ADDENDUM NUMBER 1 TO THE BID DOCUMENTS

"WILLIAMSON COUNTY LANDFILL GLASS-LINED LEACHATE STORAGE TANK INSTALLATION

CEC Project Number 195-266

Addendum Date: July 20, 2020

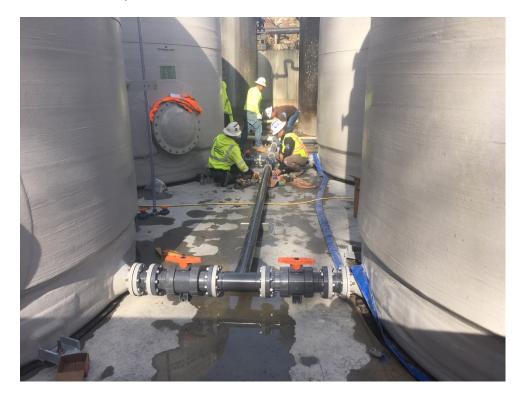
Item #3: New 6" PVC piping connecting the new glass-lined leachate tank to the existing tank farm piping will be slightly elevated off the concrete floor. Contractor is required to install the new piping to match the existing, elevated dimension of the bottom of pipe above the concrete floor as provided for the existing 4" PVC pipe within the existing tank area. (See photo below of piping in current containment area).
